AERONAUTICAL CHARTING FORUM Charting Group ACF 11-02 RECOMMENDATION DOCUMENT

FAA Control # 11-02-245

Propagating 'Automated Unicom' easily understood annotation onto Terminal Procedures (approach plates) and Sectionals.

Terminal Procedures (Approach Plates)

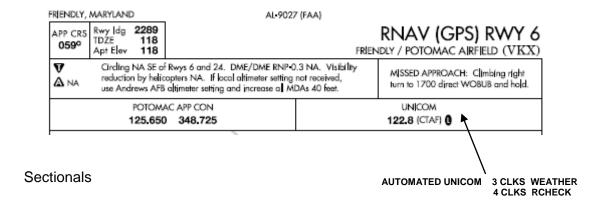
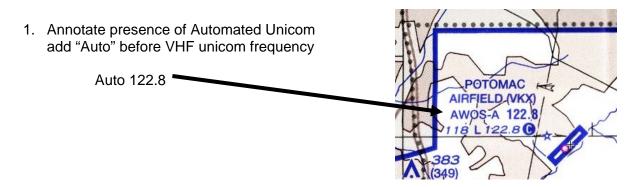
In frequency block replace "UNICOM" with "AUTOMATED UNICOM"

Avoid unnecessary contractions.

Add to the right the number of clicks to activate weather and radio-check

Based on the pilot community response, Valerie will draft an RD for submission to the MPOC/IACC with Automated Unicoms identified as AUNICOM.
